SAN ANTONIO WATER SYSTEM Addendum No. 1 To Construction Documents For 2011 WATER & SEWER CONSTRUCTION PACKAGE V SAWS WATER JOB NO. 11-5007 SAWS SEWER JOB NO. 11-5507 Solicitation #B-11-013-DD

2.2 <u>SPECIAL CONDITIONS</u> Correction PAGE SC-10

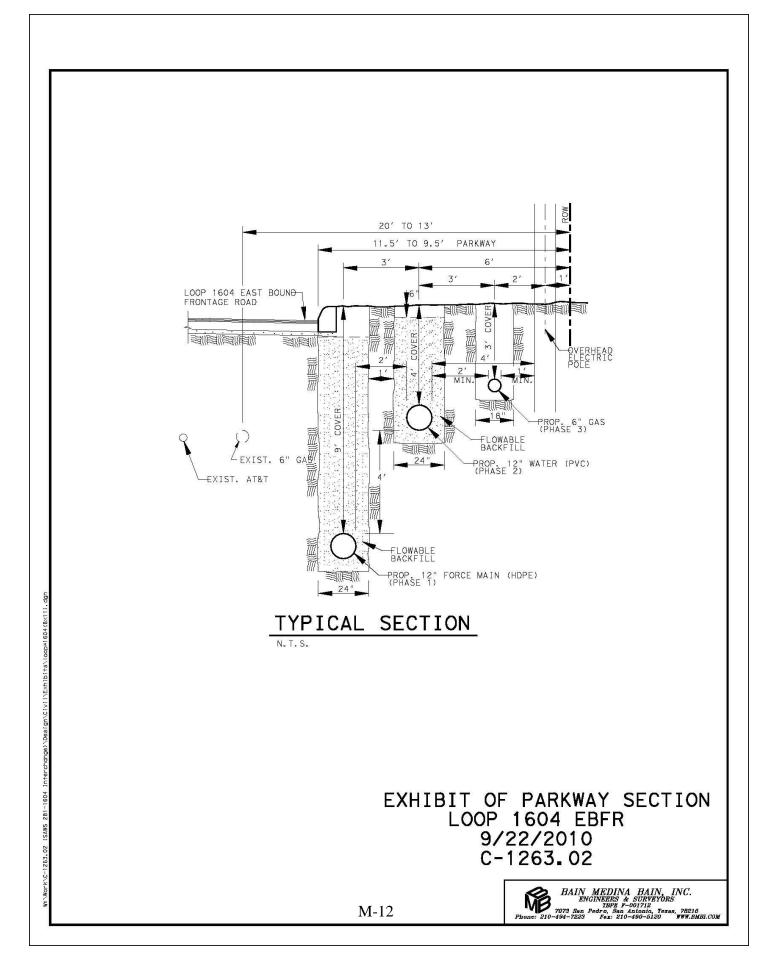
SC-2.9 (e) **INSTRUCTION TO BIDDERS:** After the first statement:

"The San Antonio Water System is currently requesting bids for three (3) Water and Sewer Construction Contracts..."

Add the following statement:

"These Construction Contracts are open cut construction contracts and are not intended to be pipe bursting or curried in place pipe (CIPP) contracts. These projects will be constructed by open cut construction or boring where applicable. Pipe bursting and CIPP will not be considered on these projects."
